January 6, 2003

FITCHBURG, MASSACHUSETTS - LOCAL PROTECTION PROJECT

SEMI-ANNUAL INSPECTION

25 October 2002

WATER RESOURCES DEVELOPMENT PROJECT
FITCHBURG, MASSACHUSETTS
NORTH NASHUA RIVER CHANNEL REHABILITATION
GENERAL PLAN NO. 1
NORTH NASHUA RIVER MASSACHUSETTS

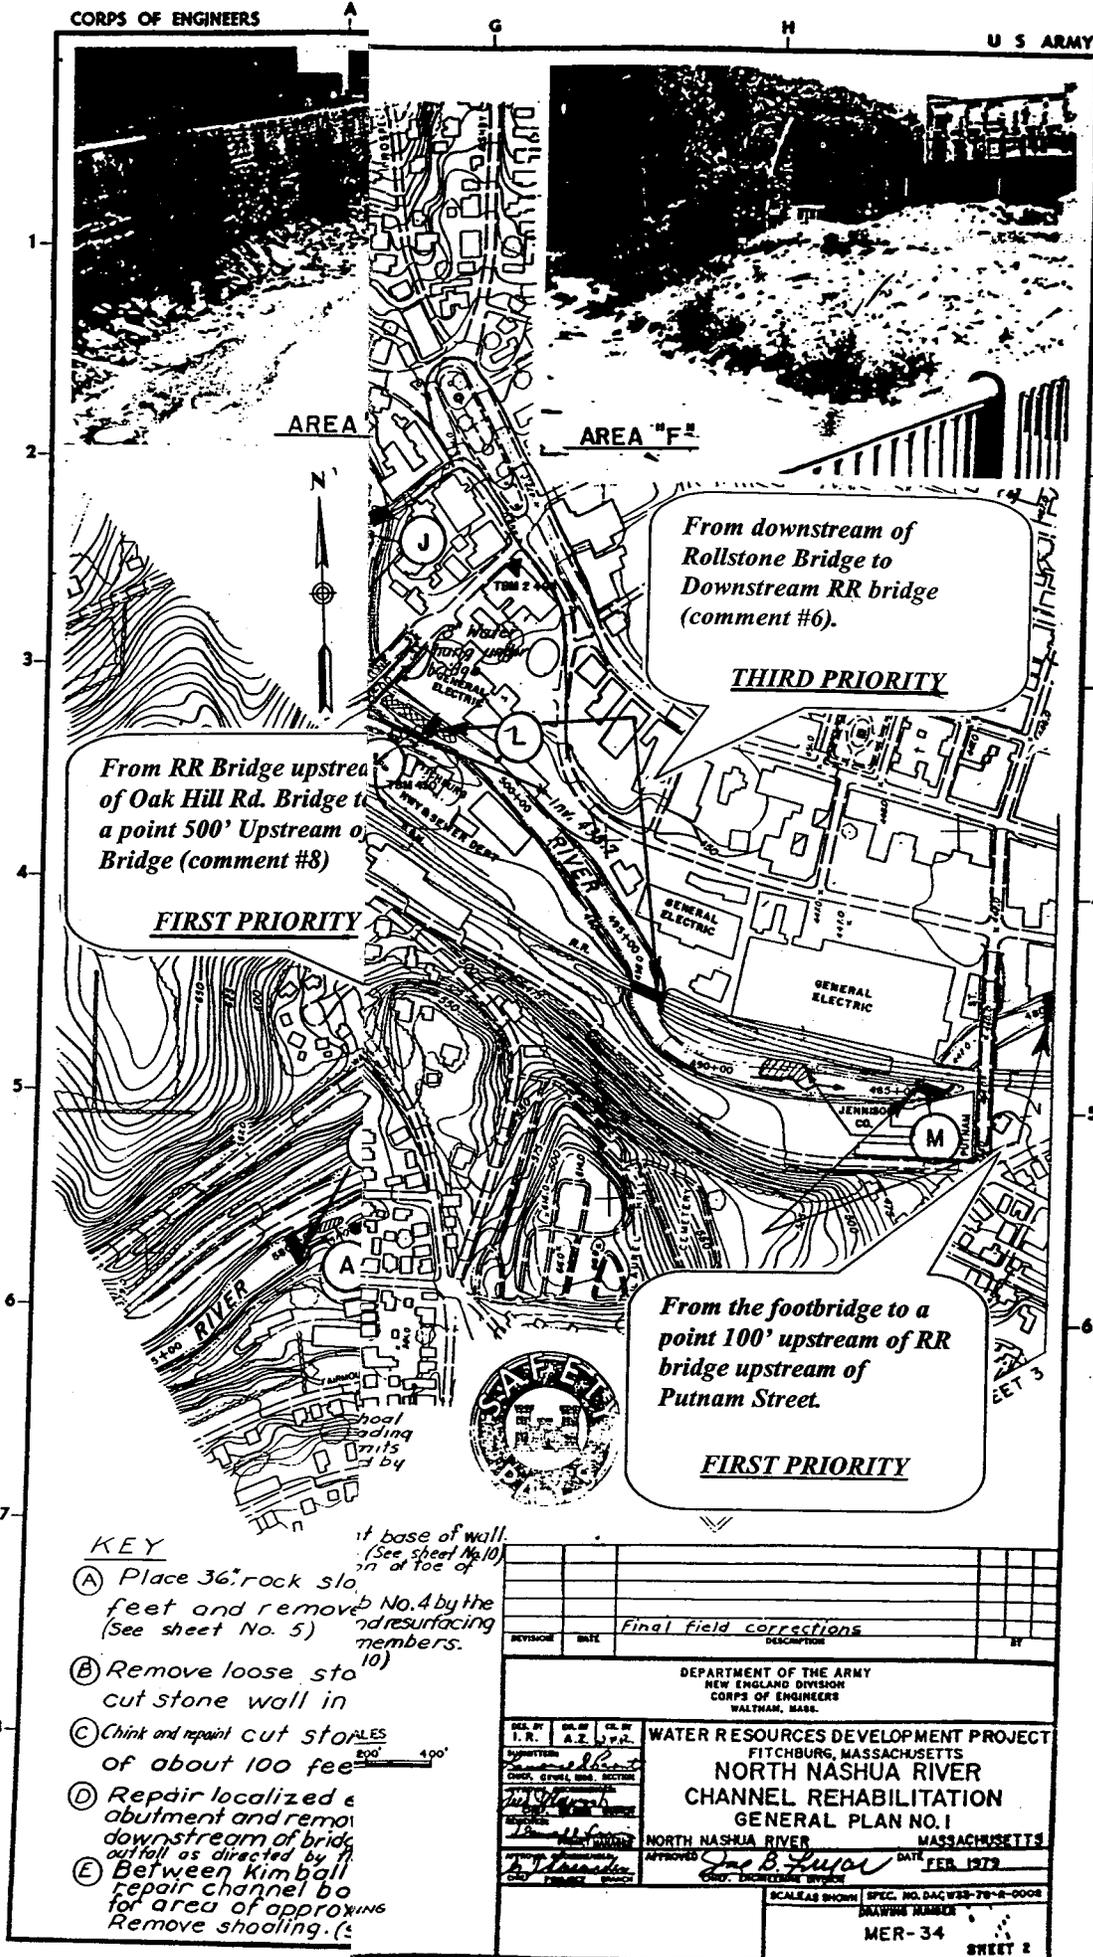
1. **Project start.** (Several hundred feet upstream of Oak Hill Road Bridge, near station 580+00)

Woody vegetation is present on the riprap slopes and stone gabions and should be removed.

2. **Oak Hill Road Bridge.** (Approximately 300 feet downstream of station 575+00)

Looking upstream - Significant vegetation, including small trees, is present on both sides of the channel. The shoal on the left bank immediately above and under the bridge appears to be expanding and should be removed.

Looking downstream - The shoal on the left bank appears to be expanding. The shoal should be removed. Vegetation covering both banks should be removed.

3. **Daniel Street Bridge.** (Approximately 300 feet downstream of station 565+00)

Looking upstream - A shoal is present in the south (left) half of the channel above the old railroad bridge. This shoal should be closely monitored. Small trees are growing in both sides of the channel.

4. **Adjacent to the McDonald's Parking Lot.** (Work areas "D" and "E" Located on the left bank downstream of Daniel Street Bridge.)

Vegetation within the banks of the channel along both sides of the river is 10 to 20 feet high.

5. **Kimball Street Bridge.** (Station 550+00)

Looking upstream – Heavy brush growth is present along both banks. A shoal on the right bank should be closely monitored.

6. **Upper River Street Bridge.** (Work area "F")

Looking upstream - Trees are growing out of the walls along both sides of the river. A large poplar is growing near the edge of the water.
